# Technical consideration of the “Report and Recommendation of the SKA Site Advisory Committee (SSAC)”.

29 February 2012

*Douglas Bock, Robert Braun, Phil Diamond, Ron Ekers, Lisa Harvey-Smith  
(CSIRO Astronomy and Space Science)*

*Lister Staveley-Smith, Steve Tingay  
(International Centre for Radio Astronomy Research)*

**Figure A1.1.** Spectra from RSA (upper plot) core site and Australian (middle plot) core sites, and ratio (in dB) of the mean power integrated over 100 MHz bins between the South African and Australian site. Positive values indicate more RFI power at the South African

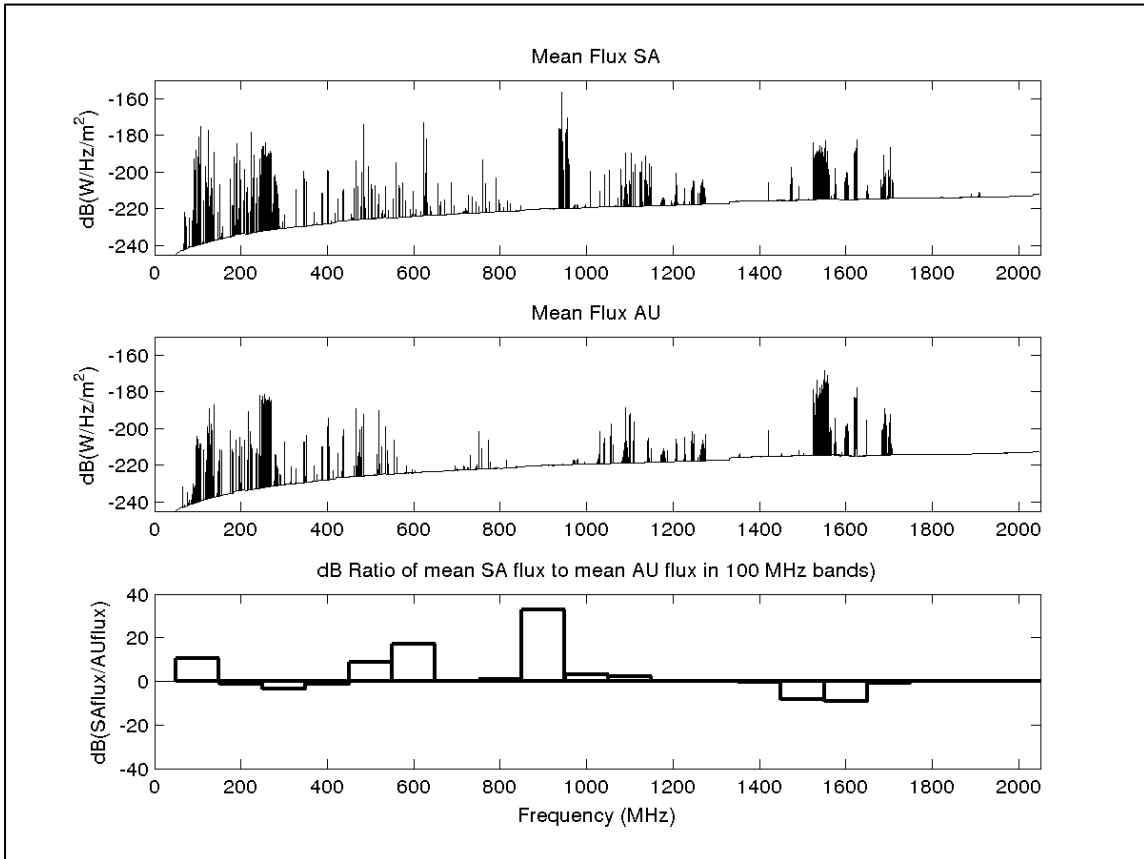
The spectra from the two datasets available are shown in the Figure below together with the ratio of the mean power integrated over 100 MHz bins at the two sites. At the Australian site, the RFI-to-noise power ratio is in all cases a very small fraction of the receiver noise. This would allow the SKA project to build high performance and lower cost radio receivers with minimal complexity. Higher RFI-to-noise ratio would carry increased design risk for the SKA.

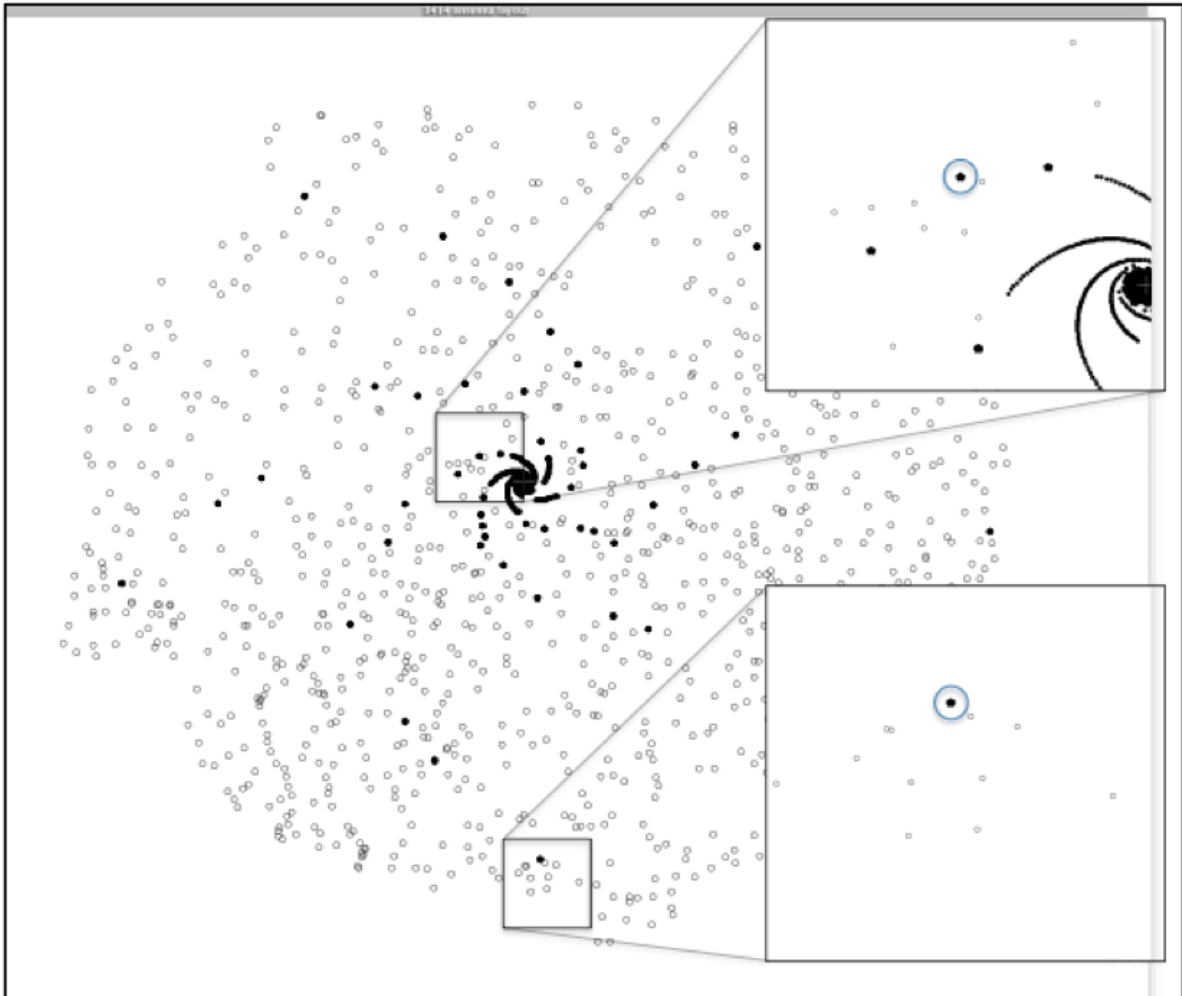
It is apparent from Figure 44 of WP3-050.020.010-TR-001 (see Figure below) that the SA configuration is immersed within more than 1000 active farmsteads (compared to 90 in ANZ) on intermediate baseline scales where individual receptors are separated by only kilometres. This does not represent an isolated setting. The EMI-risk figure of merit only addresses *system temperature* impacts on performance and does not begin to capture the much more serious consequences to scientific performance of EMI signals that produce a correlated response in the recorded visibilities within every pair of antennas that is visible to the same farmstead or farm activity (see Figure below). The EMI-risk metric treats the SKA as a collection of independent receptors. However the strength of a telescope like SKA comes from using the receptors in unison, measuring the correlations in the signals received at the antennas from celestial sources. A typical SKA visibility fluctuation for a continuum observation is only 1/10,000 of the system temperature. The EMI science impact on interferometer data is therefore potentially underestimated by the SPDO-defined risk factor by a large factor. For similar reasons, the farmhouse emissions are also damaging when using the SKA to search for transient or time-variable celestial objects, which involve baselines out to a few hundred km.

The science impacts of such correlated EMI have not yet been quantified, but they may well be substantial. This is particularly relevant for spectral line and time-domain science, which are the two top priority projects for SKA Phase 1 (SKA Memo 125, Garrett et al. 2010) and make up a large proportion of the SKA Phase 2 science case. It would appear that the EMI from farmsteads, and also from farm activity, poses a significant risk to the performance of SKA if sited in RSA; a risk that may not have been fully appreciated in the SSAC Report, where it was resolved to be “negligible”.
